STRATHFIELD LOCAL PLANNING PANEL MEETING AGENDA

Thursday 12 October 2023

TO: Strathfield Local Planning Panel Meeting - 12 October 2023
REPORT: SLPP – Report No. 5
SUBJECT: DA2023.33 - 95-97 THE BOULEVARDE STRATHFIELD
DA NO. DA2023.33

Proposal:	Alterations and additions to existing dwelling for change of use to a childcare centre and associated site works
Applicant:	Archidrome Pty Ltd
Owner:	S Jakucs
Date of lodgement:	21 April 2023
Notification period:	28 April 2023 to 19 May 2023
Submissions received:	11 – as per SPCPP guidelines
Assessment officer:	G Choice
Estimated cost of works:	\$800,000.00
Zoning:	R2-Low Density Residential - SLEP 2012
Heritage:	The subject site is located within the <i>C17 - Woodward Avenue</i> HCA
Flood affected:	Yes
Is a Clause 4.6 variation proposed?	No
Extent of the variation supported?	N/A
Peer review of Clause 4.6 variation:	N/A
RECOMMENDATION OF OFFICER:	APPROVAL

Figure 18: Proposed acoustic barrier (highlighted in blue)

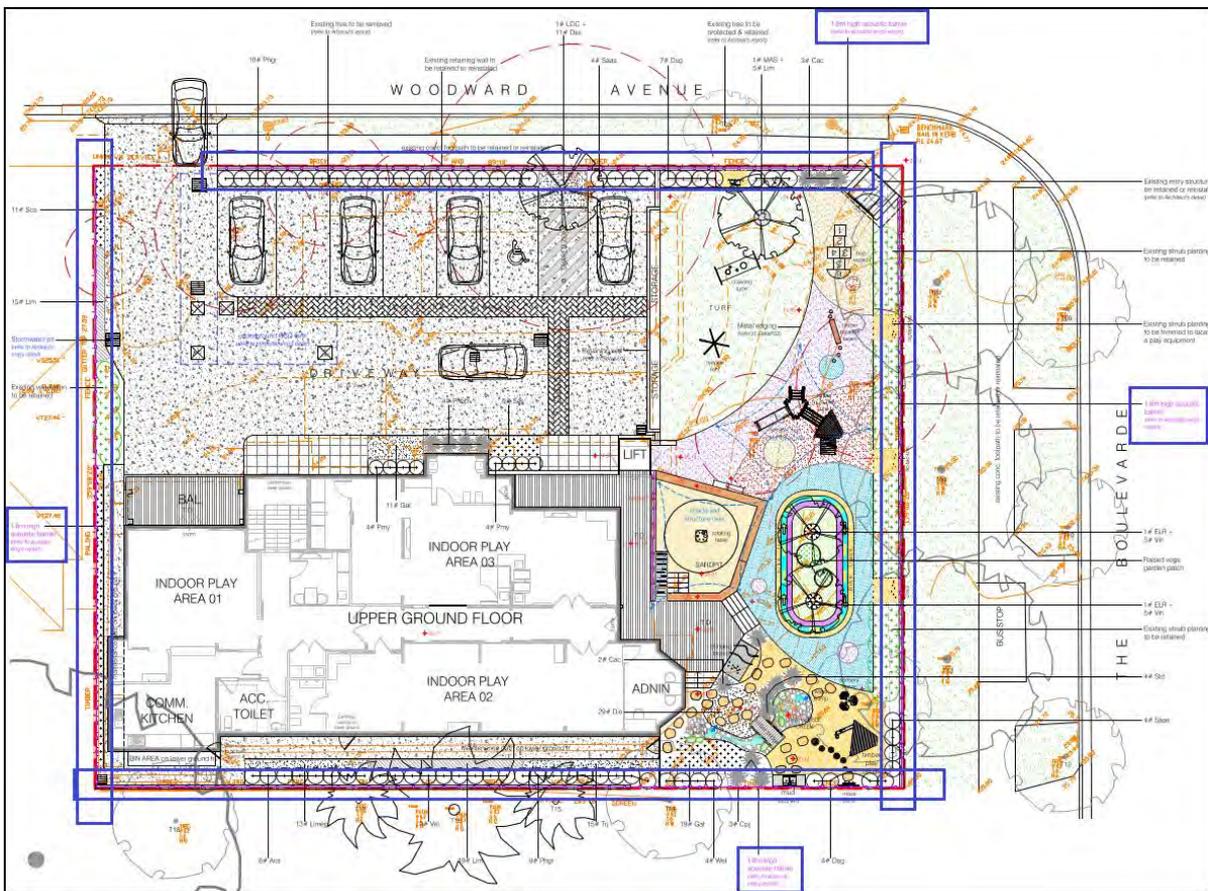
The acoustic report identifies on plans, that there is a 1.8m acoustic fence along sections of the boundary. This acoustic report has noted that compliance must be met with noise not exceeding 5dba above background, for both indoor and outdoor areas.
